Beatrice Offshore Wind Farm - Environmental Statement

BEATRICE ADDENDUM – MSS COMMENTS

MSS interim advice to MS-LOT on Common Currency spread sheets provided by BOWL and MORL, and advice received from JNCC and SNH on 28 August 2013

Location of fish and shellfish farms within the vicinity of the proposed development

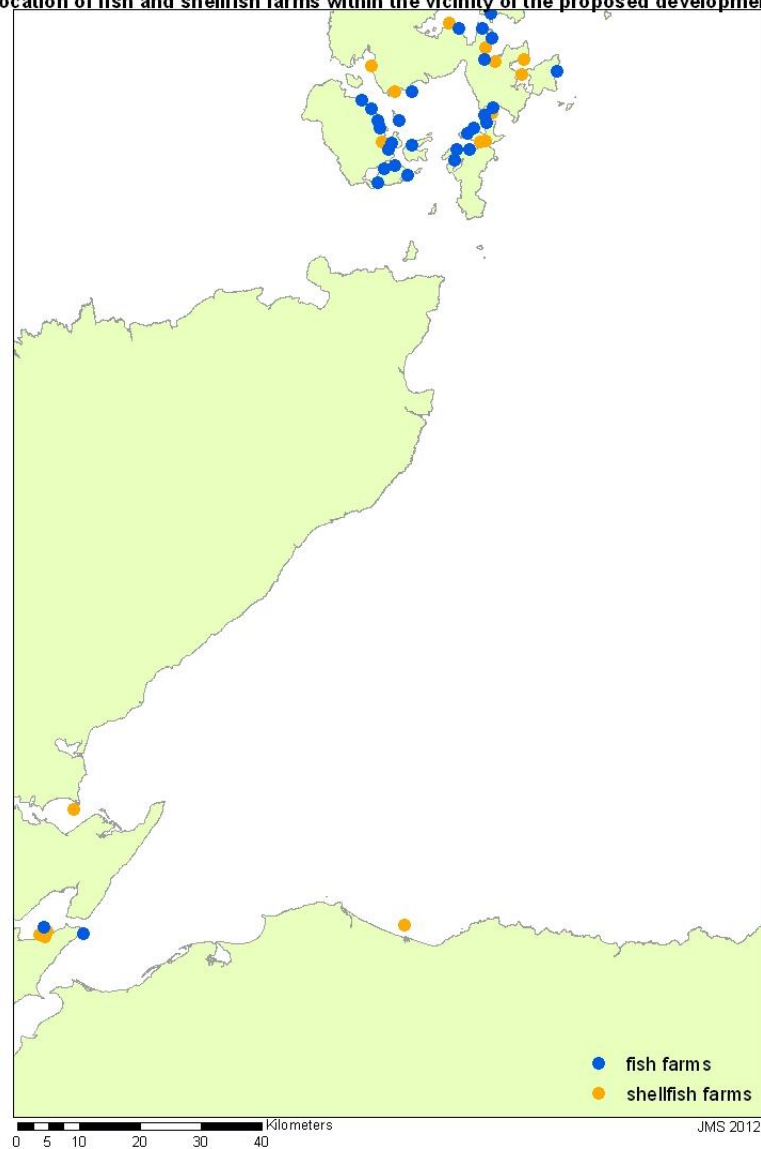
There are no aquaculture sites within the proposed boundaries of the Beatrice Offshore Windfarm site. There is however, an active mussel site close to where the cable route corridor joins the land between Norrie Scalp and Portgordon (see map attached below). This site is operated by Spey Bay Mussel Farm. This site is situated ~3km from the cable route corridor.

There are also another three active shellfish sites within the Moray Firth area, there is a mussel farm operated by Cromarty Mussels, a pacific oyster farm operated by Black Isle Seafood Ltd and another pacific oyster farm operated by MacKenzie Oysters. The closest site is ~90km from the boundaries of the Moray Offshore Wind Farm.
